TOP DRIVE
PRODUCT BULLETINS

CANRIG TD PRODUCT BULLETIN MANUAL

CANRIG DRILLING TECHNOLOGY LTD

Area where cracks may develop

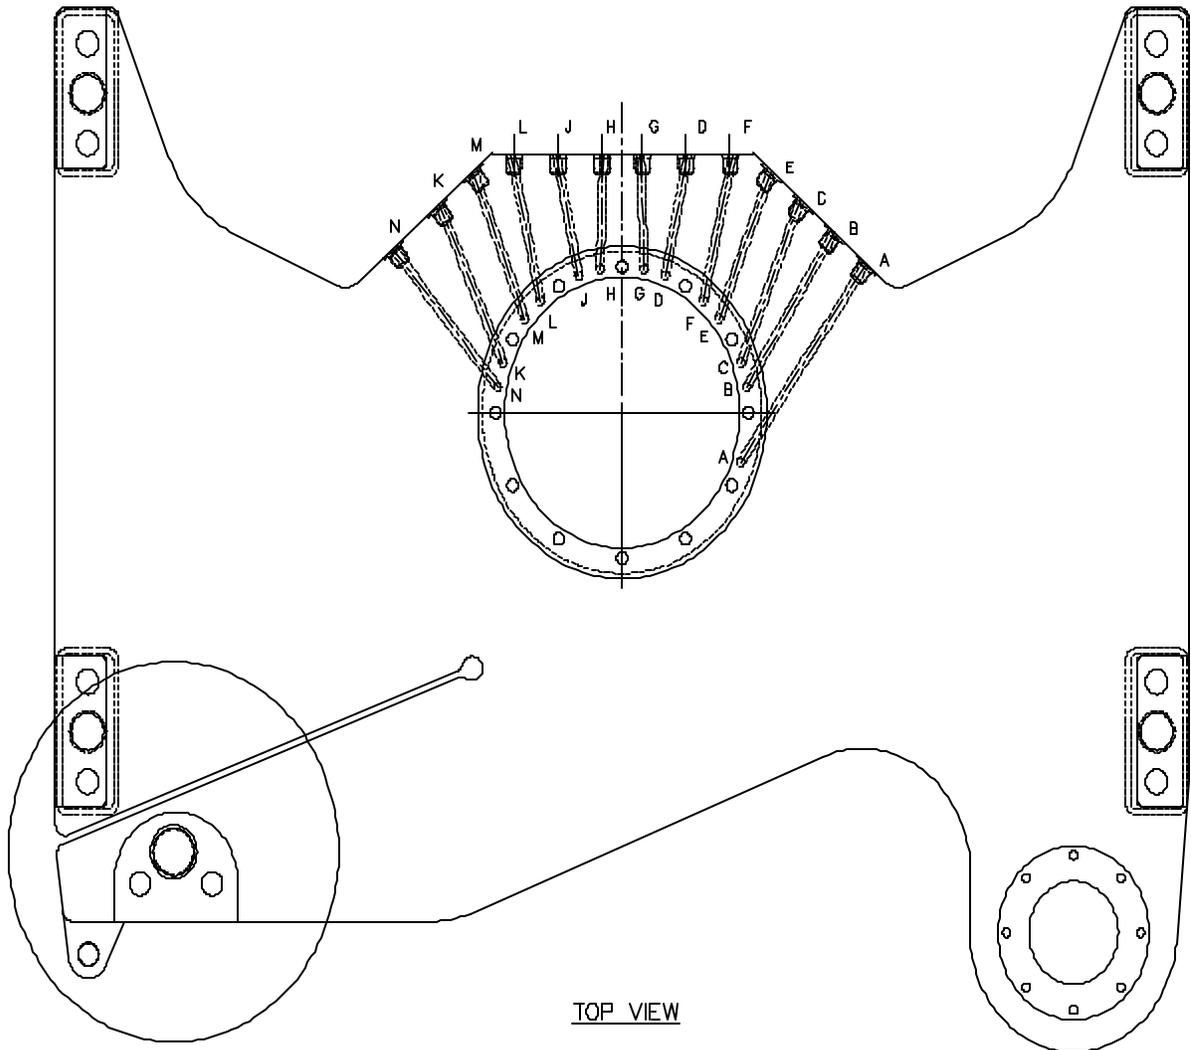
Mounting Plate drawing that shows where crack has been found

Figure 1

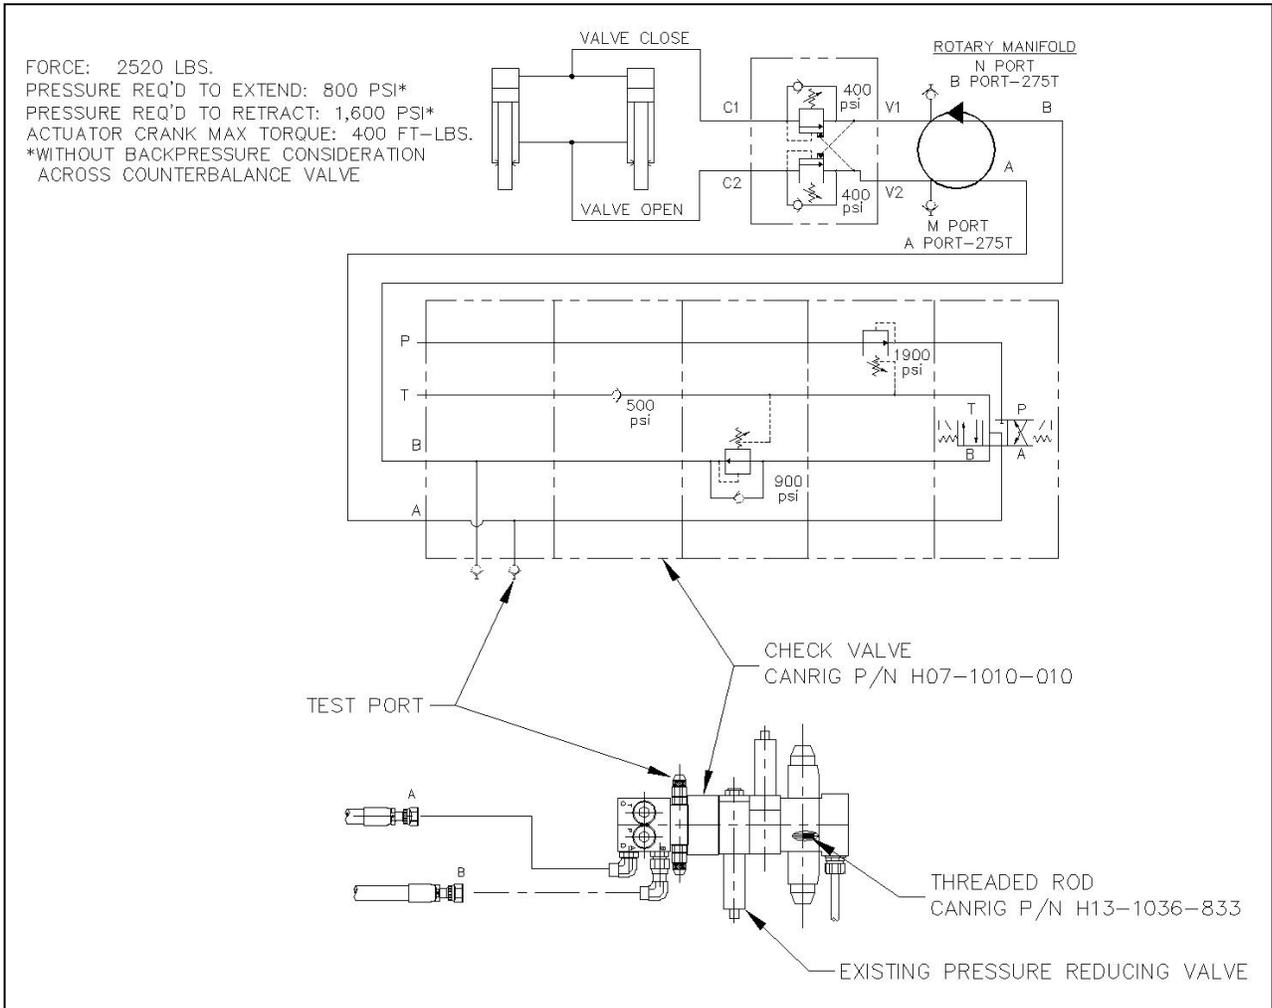
Refer to Figure 1 (shown below). Disassemble valve stack noting position and orientation of each valve. Remove existing threaded rods from hydraulic manifold. Install new longer threaded rods (Canrig P/N H13-1036-833) in manifold. Reinstall test port assembly (previously removed) and install check valve (Canrig P/N H07-1010-010) in position on manifold noting proper position of ports. Reinstall previously removed valves in same orientation as noted when removed. Reinstall threadnuts (Canrig P/N H13-1035-01A). Set pressures of all valves as shown in Figure 1.

Figure 2

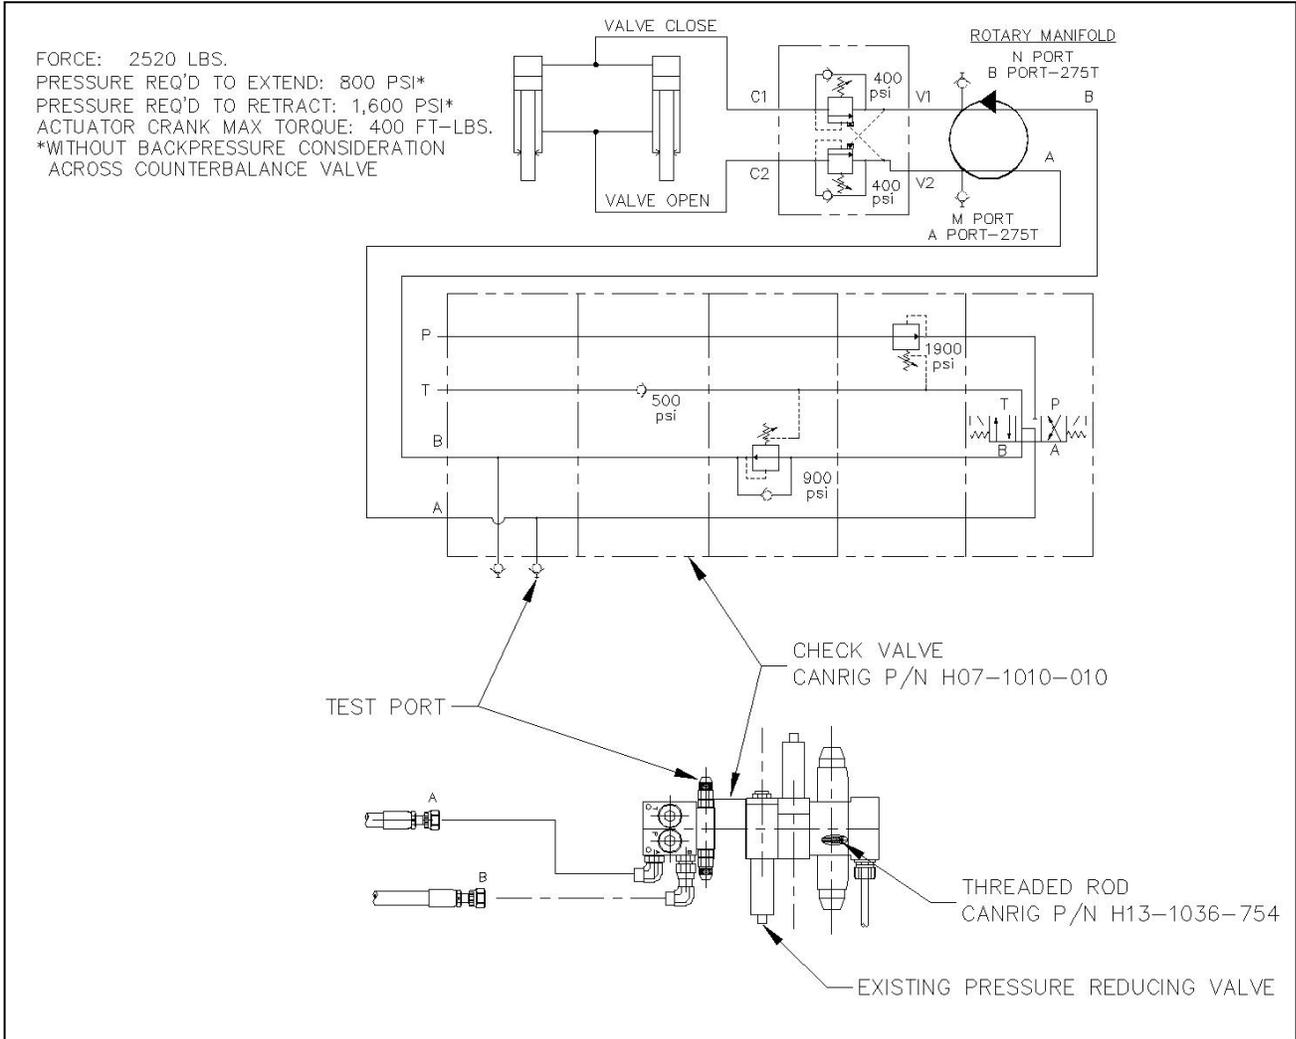
Refer to Figure 2 (shown below). Disassemble valve stack noting position and orientation of each valve. Remove existing threaded rods from hydraulic manifold. Install new longer threaded rods (Canrig P/N H13-1036-754) in manifold. Reinstall test port assembly and install check valve (Canrig P/N H07-1010-010) in position on manifold noting proper position of ports. Reinstall previously removed valves in same orientation as noted when removed. Reinstall threadnuts (Canrig P/N H13-1035-01A). Set pressures of all valves as shown in Figure 2.

Figure 3

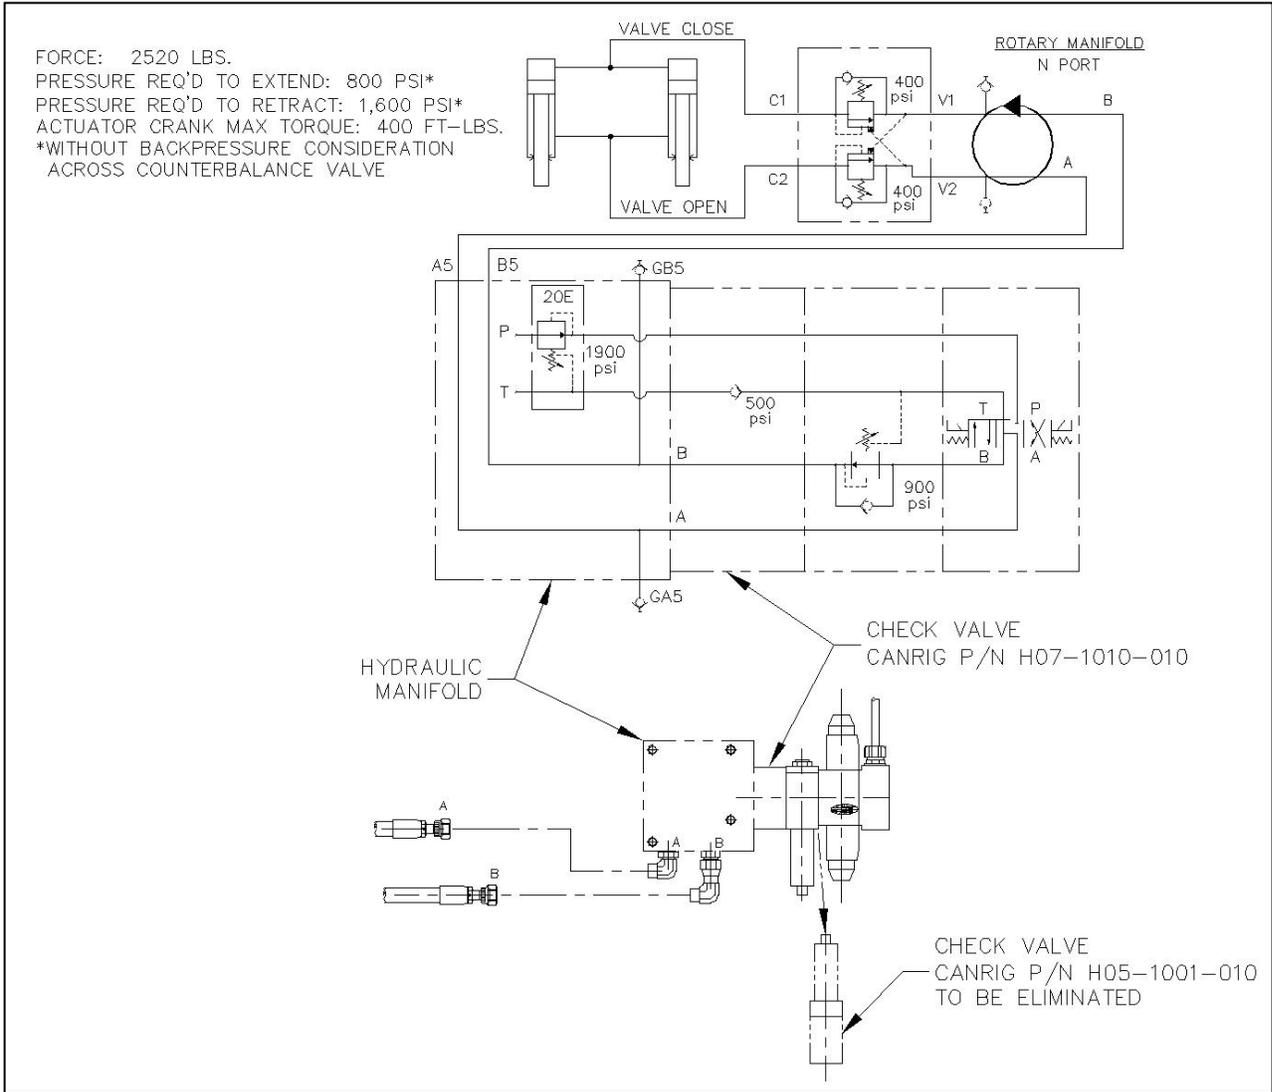
Refer to Figure 3 (shown below). Disassemble valve stack noting position and orientation of each valve. Discard pressure reducing valve (Canrig P/N H05-1001-010) as shown in Figure 3. Install check valve (Canrig P/N H07-1010-010) in position on manifold noting proper position of ports. Reinstall previously removed valves in same orientation as noted when removed. Reinstall threadnuts (Canrig P/N H13-1035-01A). Set pressures of all valves as shown in Figure 3.

EXISTING SECTION 2

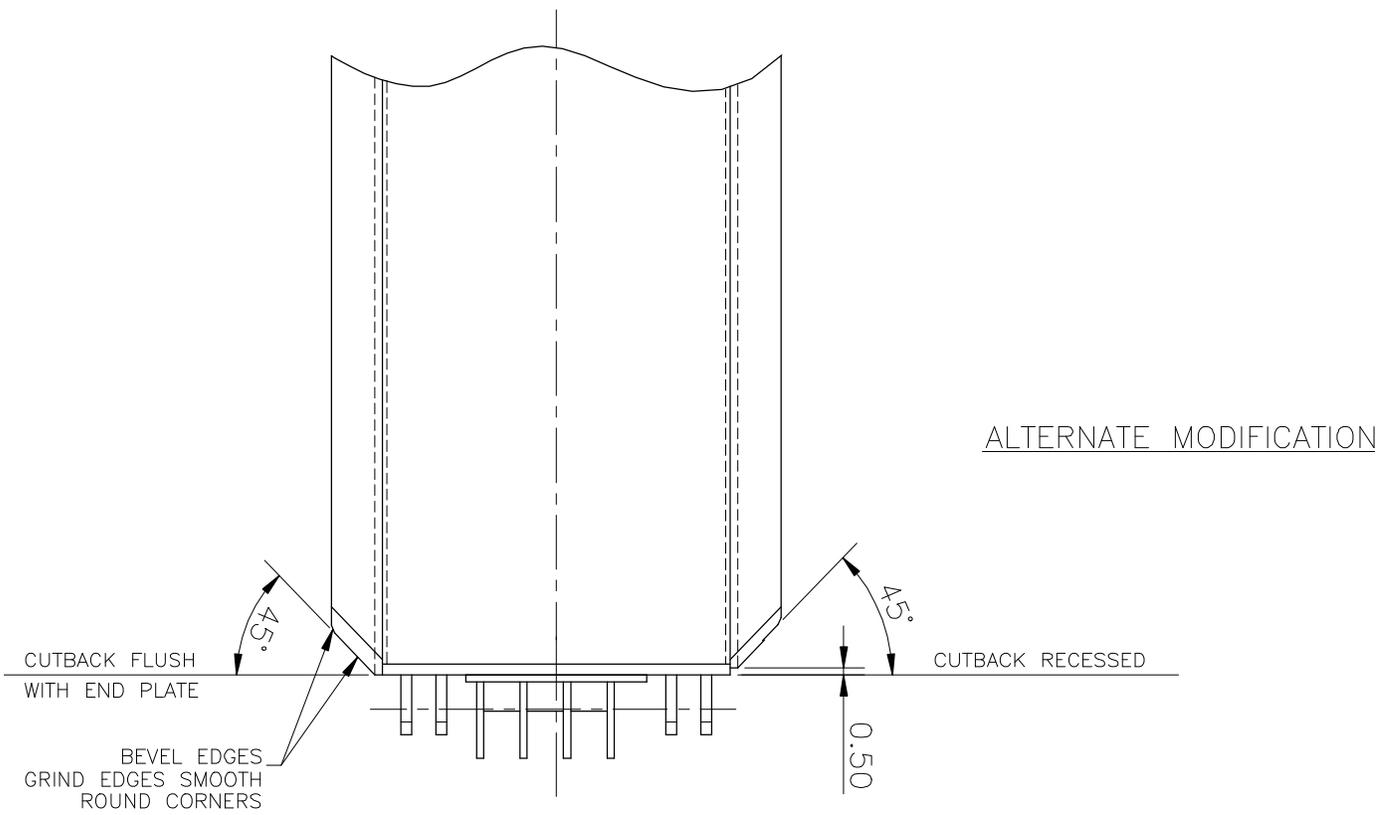
1. The blower needs to be further protected with the addition of a deflector plate which is welded to the top drive guard. The deflector plate should be constructed as shown in Fig.1. Ensure that the edges shown are well rounded to prevent tugger lines from getting caught on it.
2. Cut away the perforated plate in the area shown in Fig.2. Replace the cut away piece with $\frac{1}{4}$ " thick plate or flat bar which measures 2.50" x 6.00 ". This is to allow a stronger weld between the top drive guard and the deflector plate.
3. Weld the deflector plate onto the lower blower guard as shown in Fig.2. The plate should be centered on the pipe and a $\frac{1}{4}$ " fillet weld should be placed all around the plate on both sides.

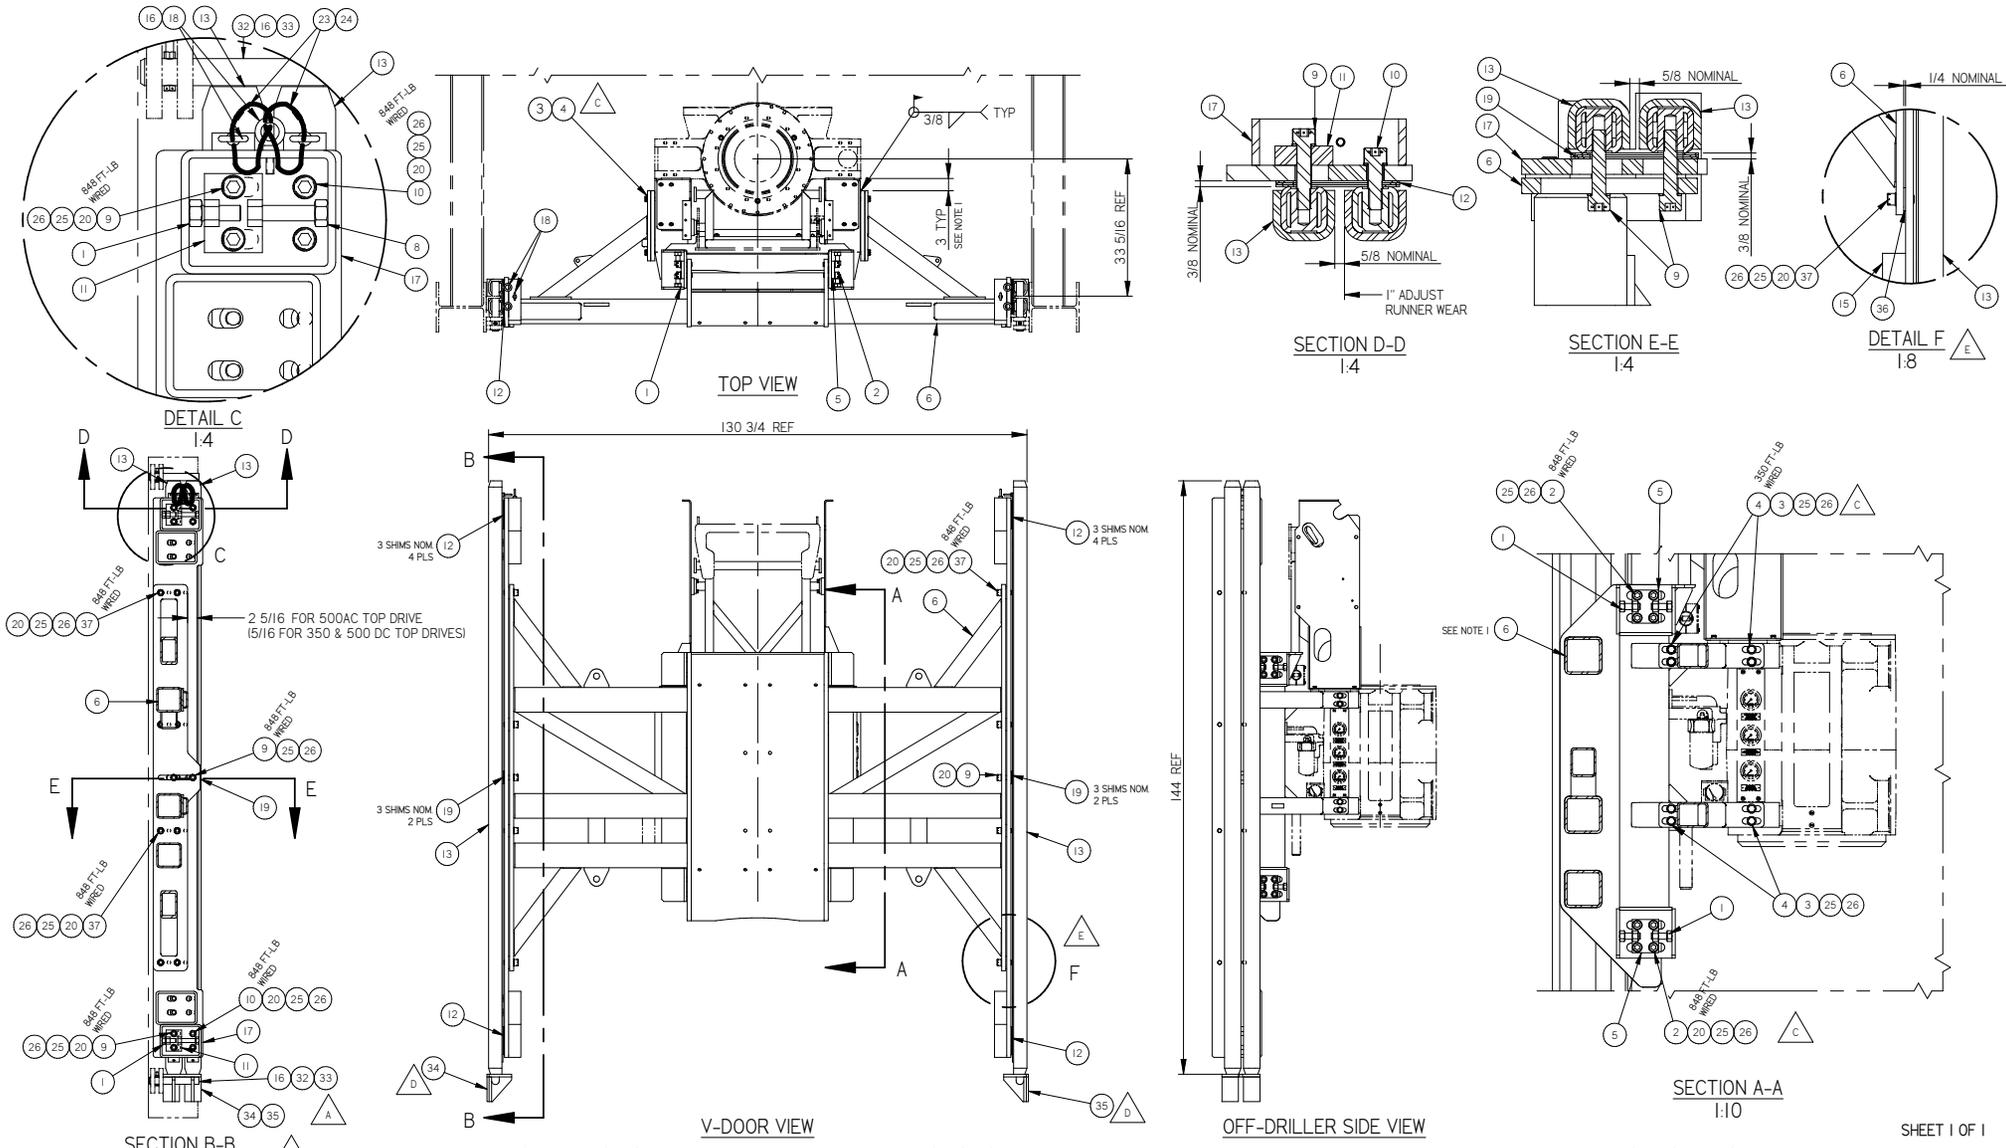
RECOMMENDATION: The recommended gap between the guide rail and the runner is between 1/8" and 3/16". To achieve this on the F-Rigs we have created a kit to shim the guide runner frames out to the narrowest point in the mast rails. NOTE: All items below refer to Assembly Drawing AY12949 Rev E. Attached

3. The existing top drives in the field should already have at least 1/4" of shim behind each runner. This should stay as is on the top drive with no less than the 1/4" of shim installed.
4. To determine how much shim you will need, subtract the outside to outside distance of the guide runners on the top drive from the narrowest inside to inside measurement on the guide rails. Subtract 1/8" from this number and this is how much shim that will need to be added between items 15, 17 and item 06. The shims, items 36A, 36B and 36C, come in 1/2, 1/4 and 1/8 widths. (See attached drawing AY12949 to locate items)

Fig. 1

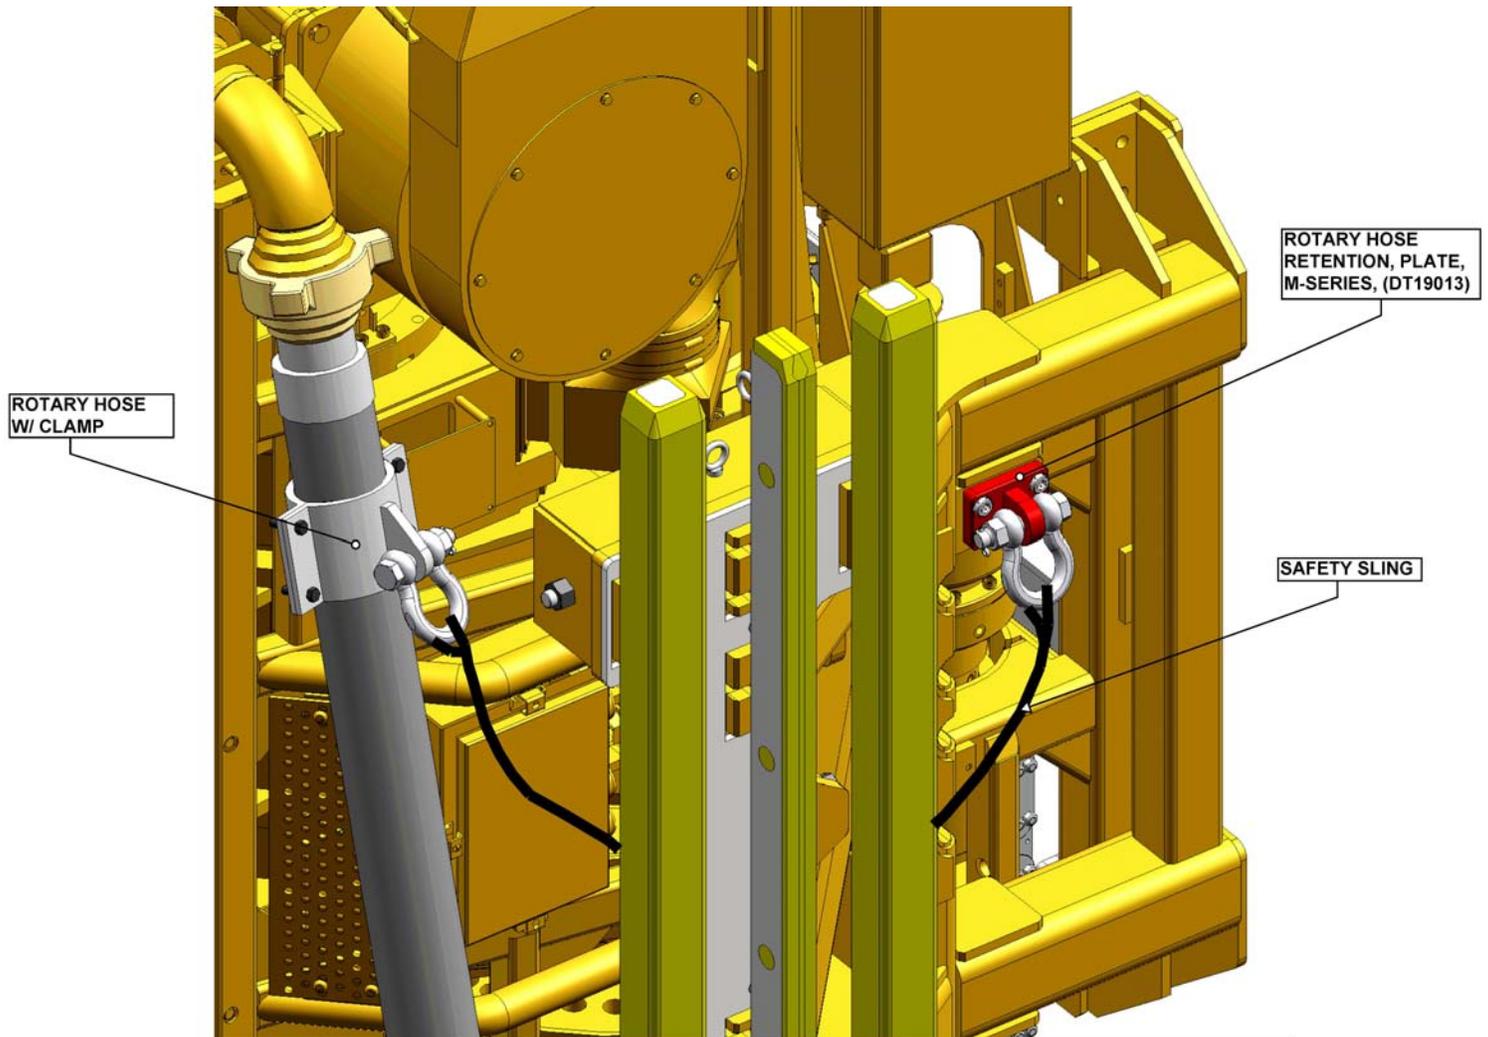
1. Remove existing (4) $\frac{3}{4}$ "-10UNC capscrews from M-rig Guide Frame and replace with Rotary Hose Retention Kit for M-series (AY16645) which includes Rotary Hose Retention Plate (DT19013) with longer capscrews (4) $\frac{3}{4}$ "-10UNC x 3 $\frac{1}{2}$ " (SH-0750NC-0350-W-GR8) and (4) Nordloc washers (LW-0750-NLS). Rotary Hose Retention Plate (DT19013) is installed on top of the existing M-rig Guide Frame. See Fig. 1.
